**PROJECT NAME: IN076 ICTC– REPLACE BACKUP CHILLER & UPS UNITS**  
**OWNER NAME: INDIANA UNIVERSITY**  
**IU PROJECT NO. 20231522 / CES PROJECT NO. 2024-007.ICT**  
**ADDENDUM NO. 1**  
**DATED: NOVEMBER 13, 2024**

For: IN076 ICTC Building Chiller Replacement and UPS Replacement  
Indiana University Indianapolis. IU 20231522

ED101

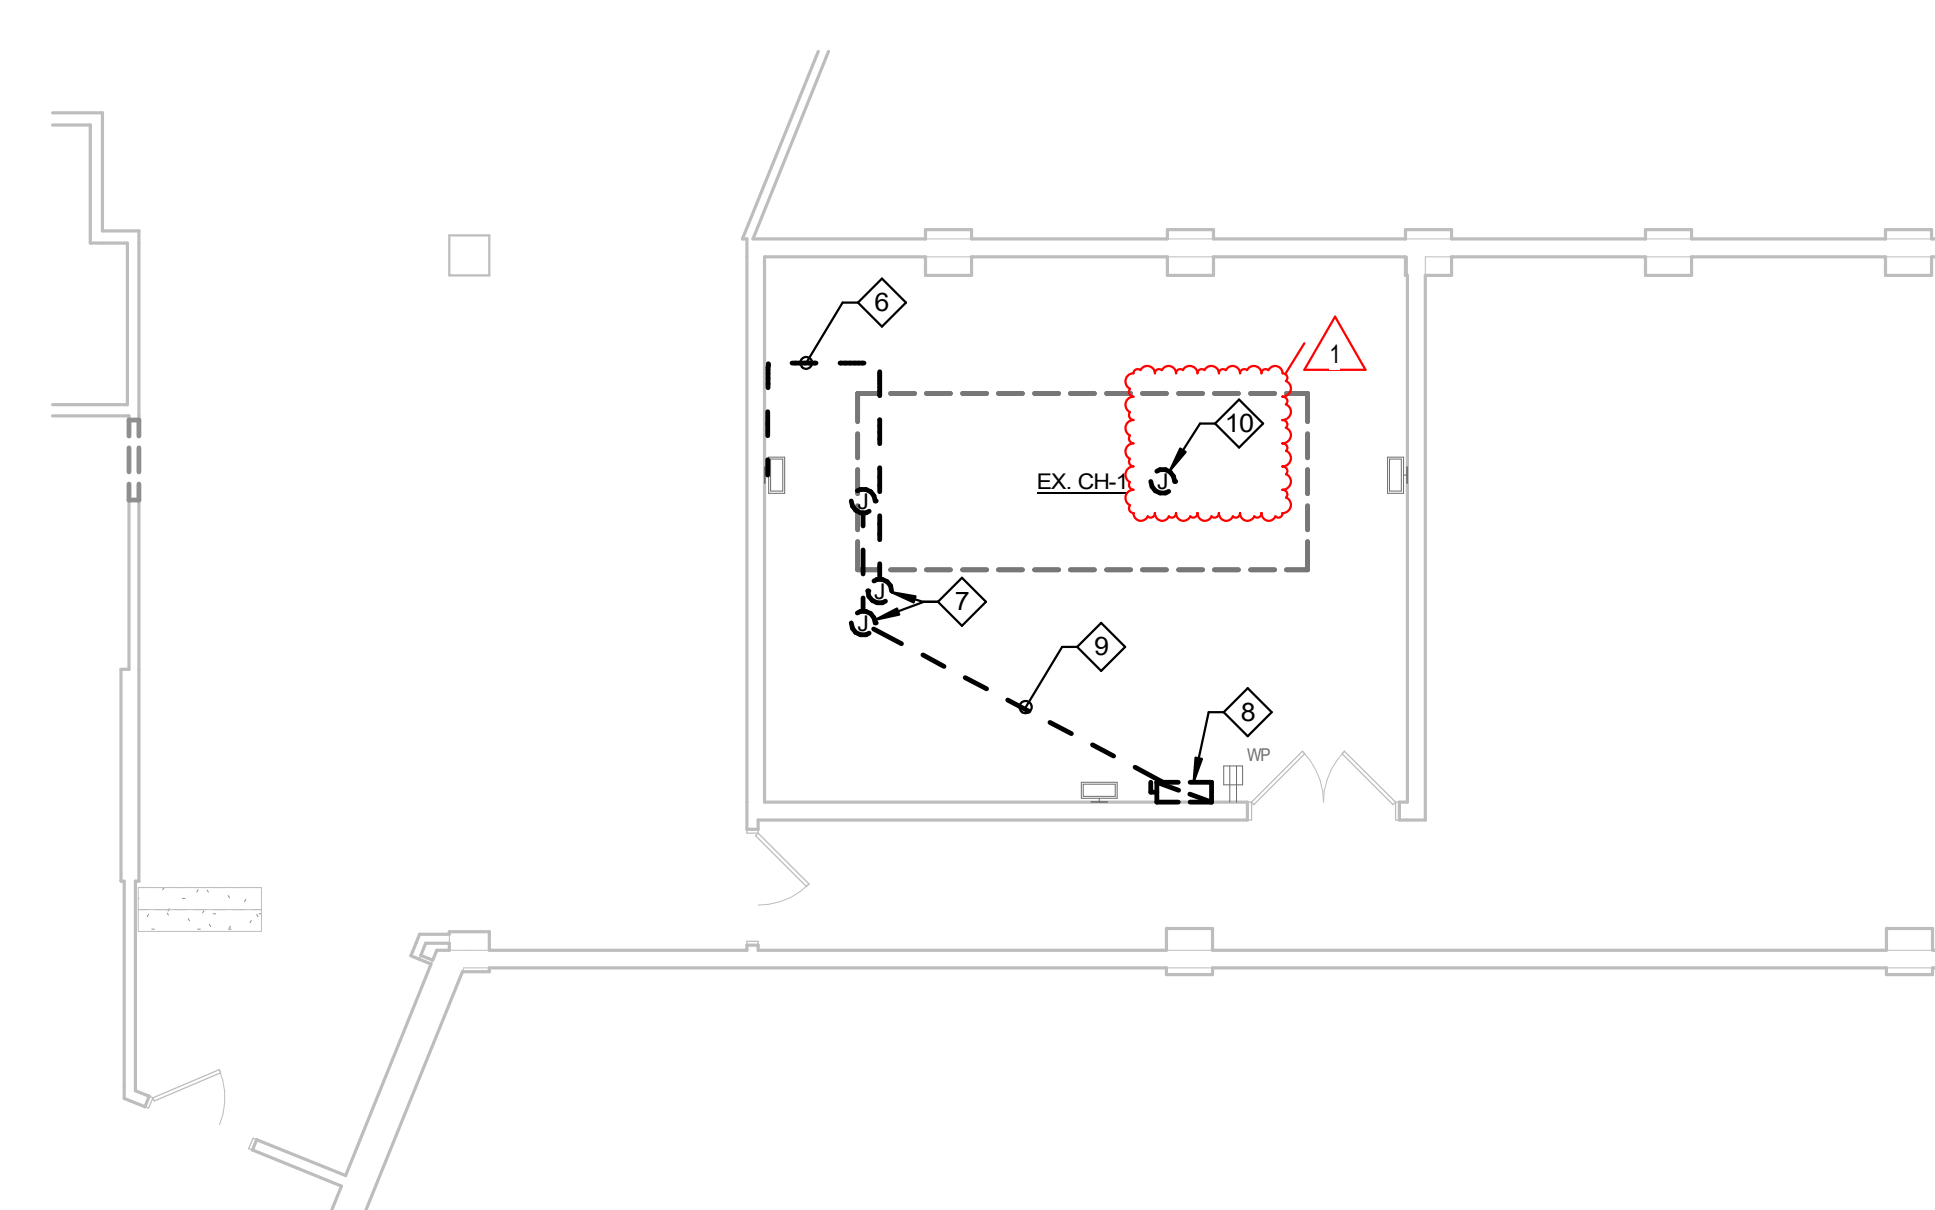
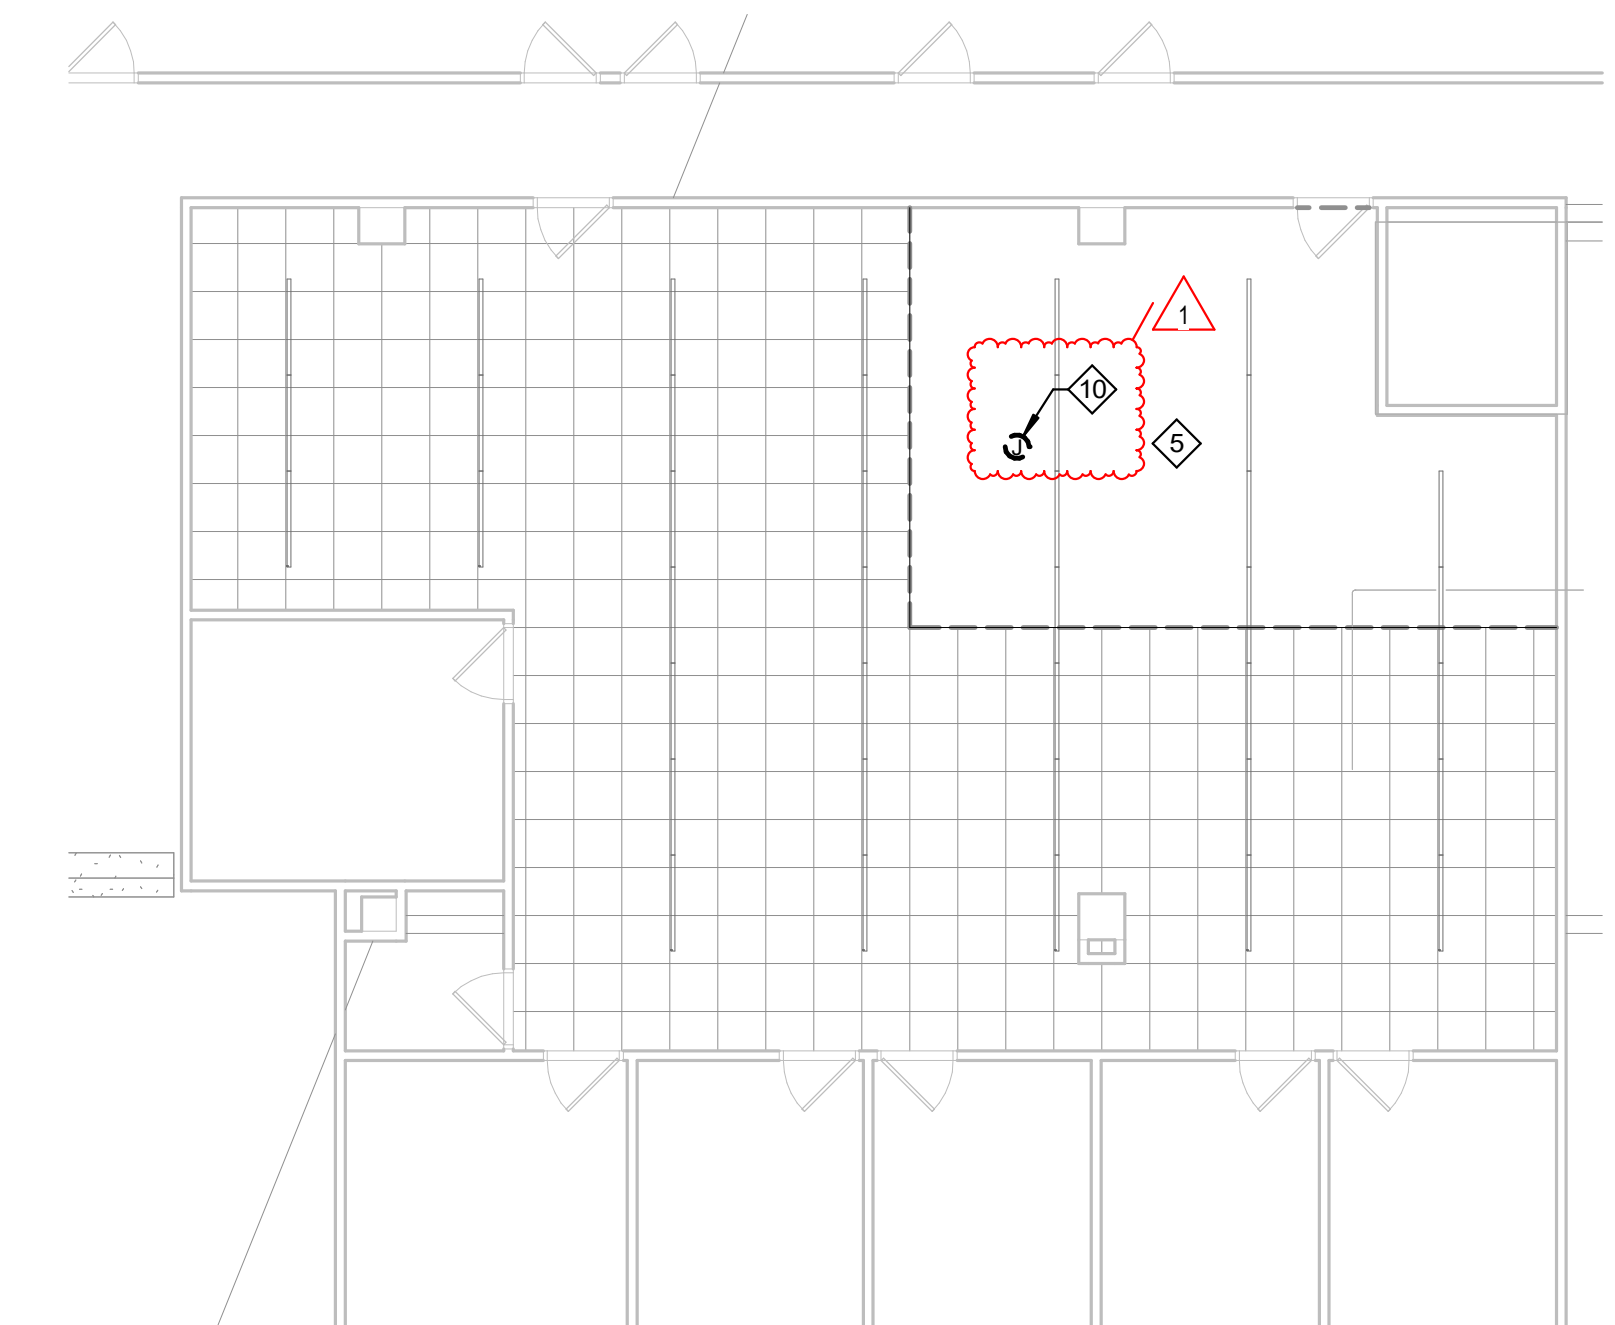
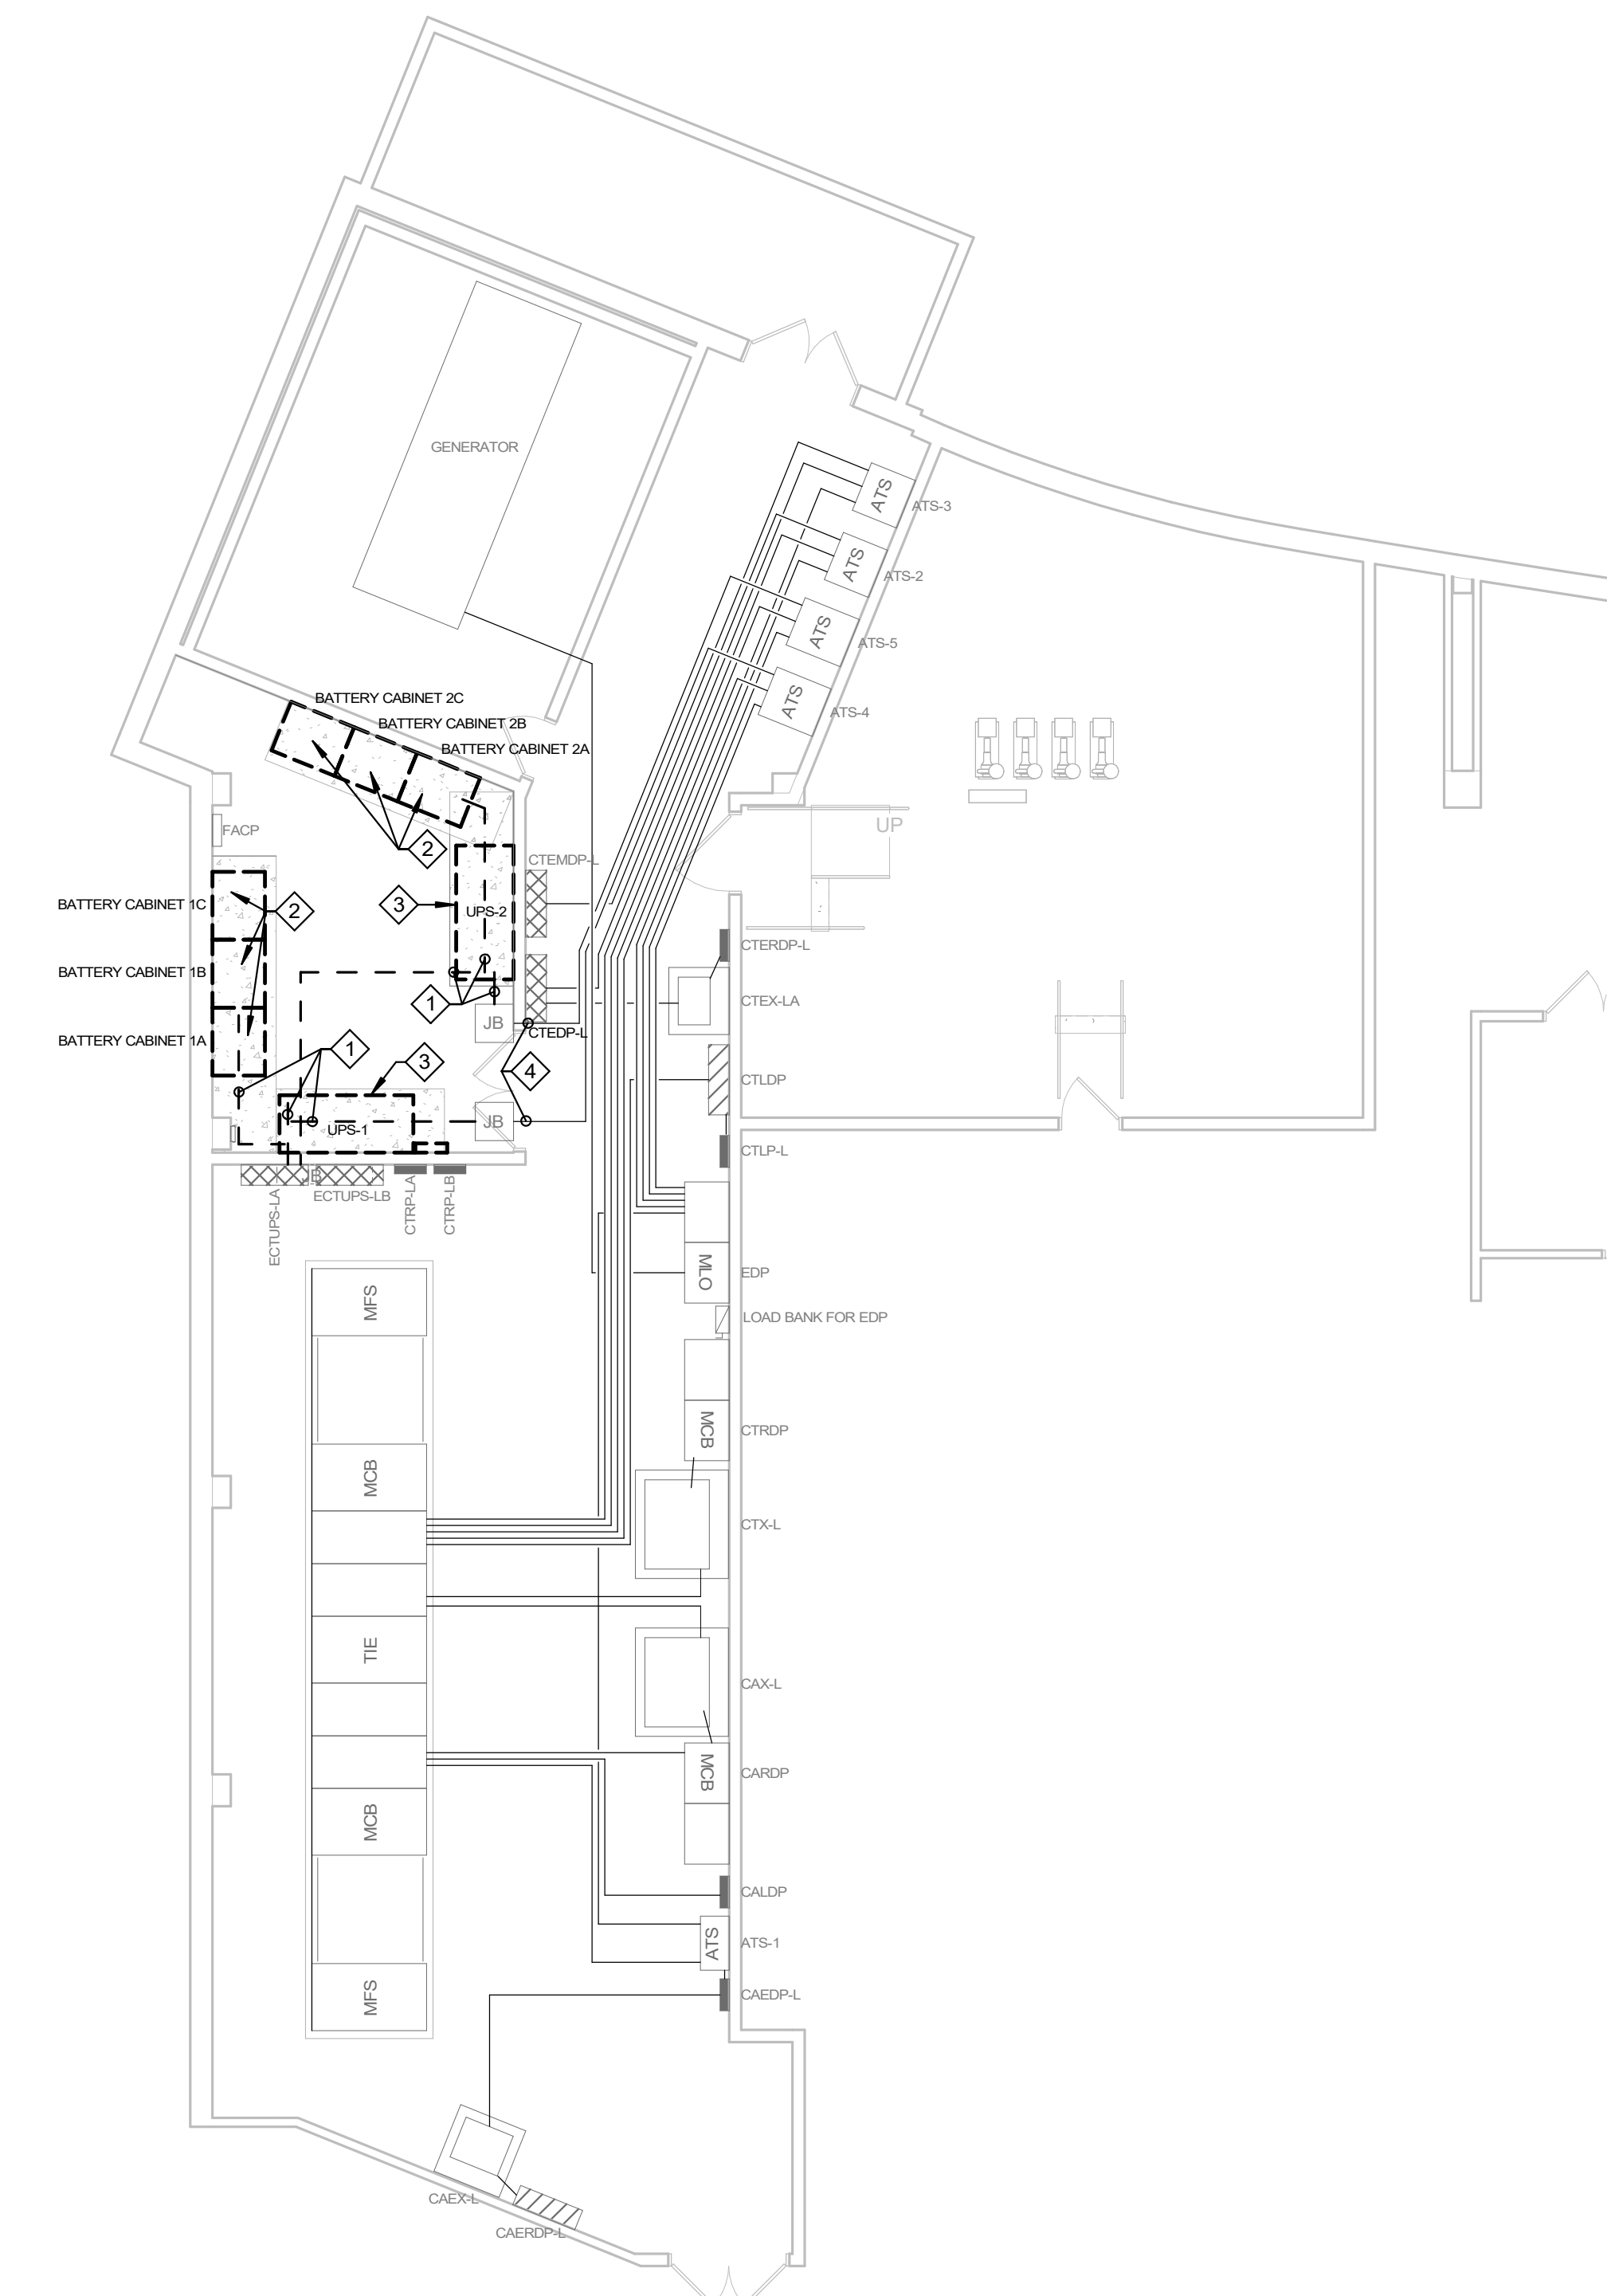
1. DELETE AND REPLACE Drawing in its entirety.  
Added note to remove heat tracing to chiller.
